**Response to**

**Request for Additional Information No. 340, Supplement 3**

**U.S. EPR Standard Design Certification**

**SRP Section: 06.02.01 - Containment Functional Design**

**Figure 06.02.01-53-42—Flow Circulation Patterns in the Containment 1 second into Blowdown**

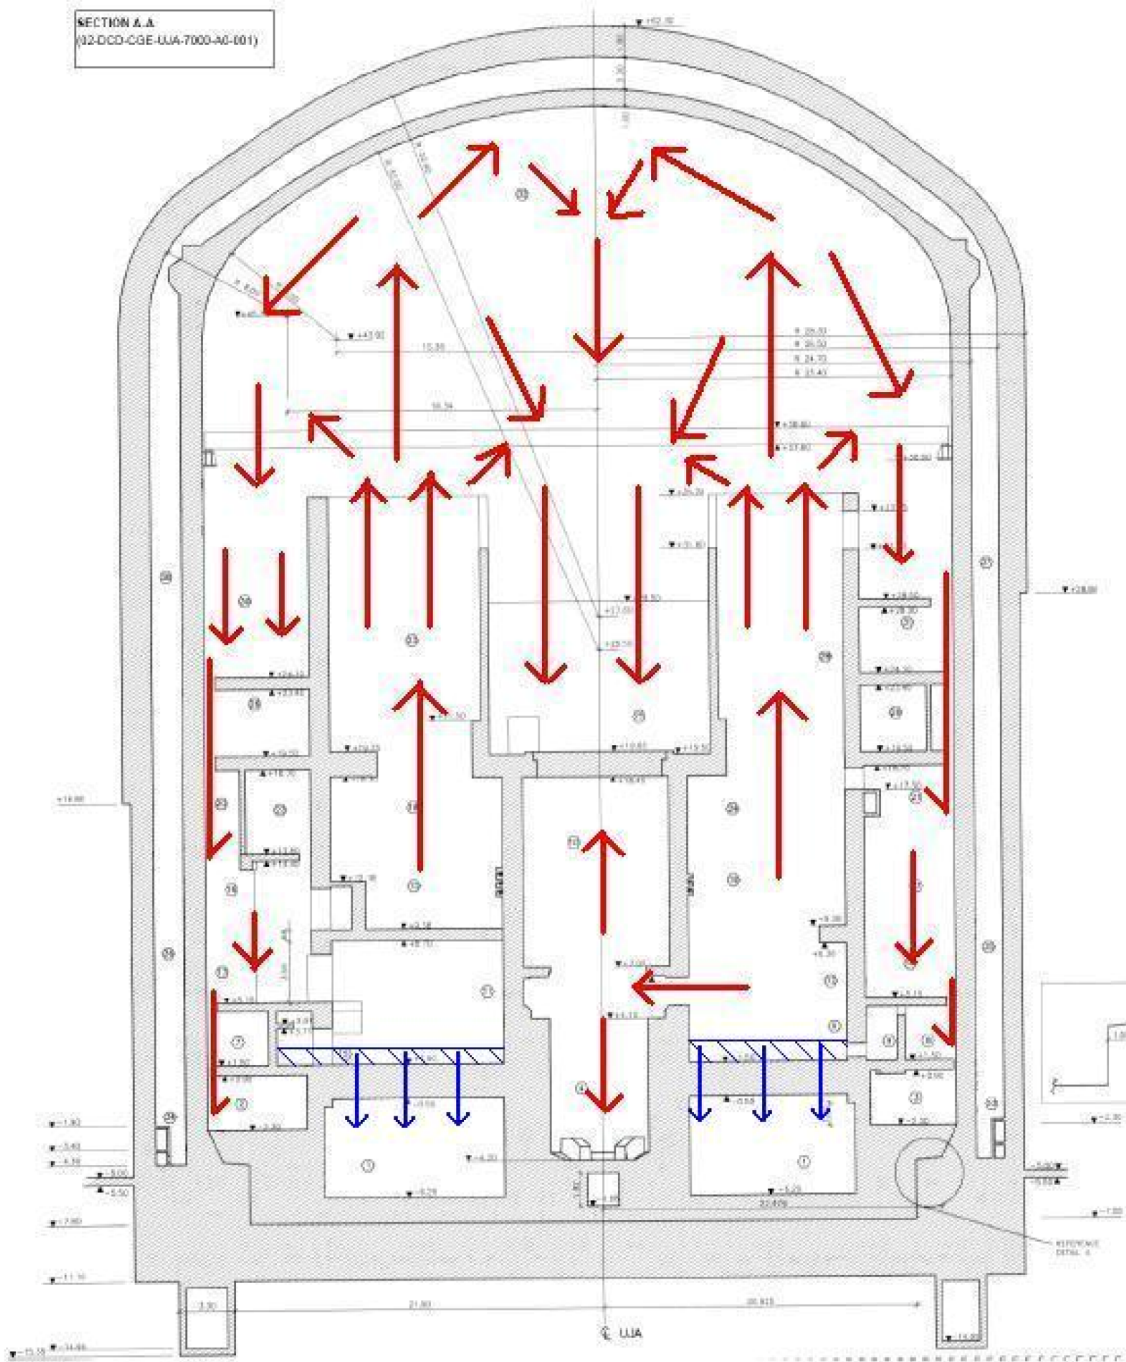
Please provide detailed results, similar to the RAI 1, Supplement 7 data, for a DE CLPS LOCA with non-safety doors closed. Also, provide discussion and illustration of flow patterns observed during the early blowdown phase and just prior to initiation of hot leg injection. Discuss observed thermal stratification in the entire containment (do not limit the discussion to the dome).

The following plots are provided to illustrate the flow patterns observed in the limiting U.S. EPR FSAR cold leg pump suction analysis (U.S. EPR FSAR Table 6.2.1-1: Case 40) where all of the non-safety doors remained closed for the duration of the transient. A representative nodalization diagram is shown in AREVA NP technical report ANP-10299, Rev. 2, "Applicability of AREVA NP Containment Response Evaluation Methodology to the U.S. EPR™ for Large Break LOCA Analysis," Figure 9-7. The flow circulation patterns are shown in Figures 06.02.01-53-1 through 06.02.01-53-41. The blowdown phase dominates the response as the later portions of the event evolve to a steady-state condition. The magnitude of the circulation patterns in the containment is significant for the first 30 seconds after the break coincident with the high break flow rates during the blowdown phase. Immediately following the opening of the rupture foils located at the top of the steam generator (SG) cubicles, vapor rapidly exits from the equipment rooms to the dome and is then distributed throughout the containment. Flow from the dome to the middle annulus rooms is shown in Figures 06.02.01-53-30 and 06.02.01-53-32. There is also flow passing from the loop 1 and 2 upper annulus room to the dome, as shown in Figure 06.02.01-53-33. Initially, the flow direction is from the dome to the upper annulus room; however, after several seconds into the transient, the flow reverses. The flow circulation patterns during blowdown are also shown in Figure 06.02.01-53-42.
